**IRRIGATION, RURAL LIVELIHOOD
AND
AGRICULTURE DEVELOPMENT PROJECT**

**KAPICHIRA DAM AND SHIRE VALLEY IRRIGATION PROJECT
VISIT REPORT BY PANEL OF EXPERTS**

Jan 31, 2017

Figure 6.1: Recommended position of SVIP Intake

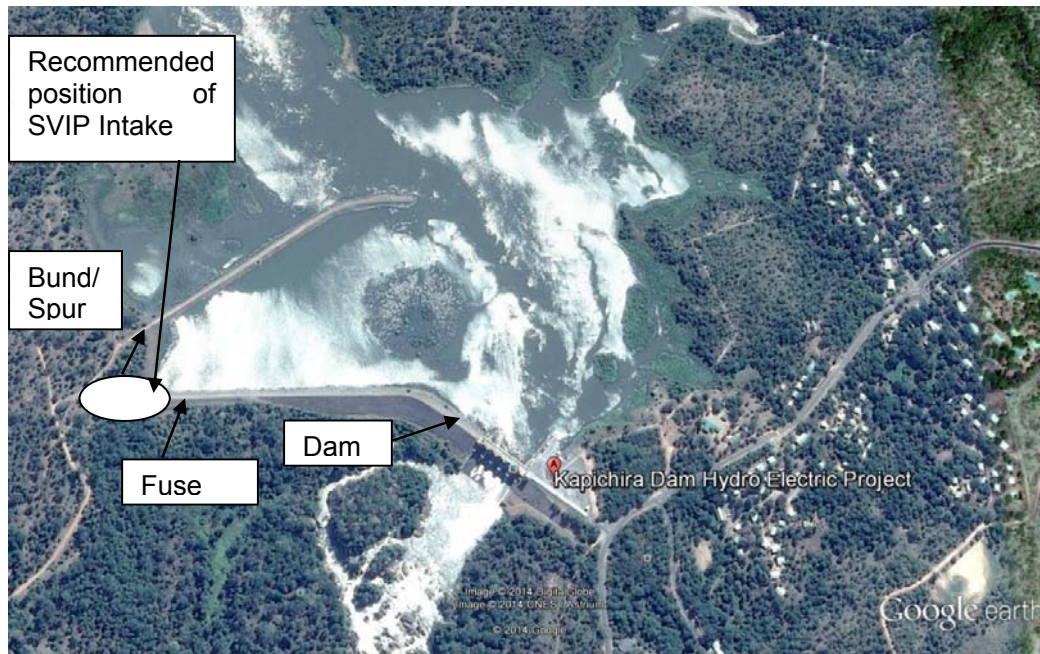
During the meeting of Jan 27 EGENCO expressed concern on the proposed location of SVIP intake on the downstream side of the dyke. Their concern is that it may lead to parallel flows along the dam and may result in damage to the rip rap as happened in 2004.

It is recommended that SVIP and EGENCO management discuss EGENCO's concerns and try to answer the EGENCO's concerns, which can probably be further alleviated by construction of a dyke on the left side of the approach channel of the intake of SVIP more or less parallel to the existing dyke. The location and length of this dyke could be optimised on the hydraulic model, which should clearly demonstrate that the proposed location of the SVIP intake will not result in flows parallel to the dam.

In view of the above POE recommend another run of the ARTELIA model incorporating a dyke running approximately parallel to the spur dyke from the left hand side of the intake.
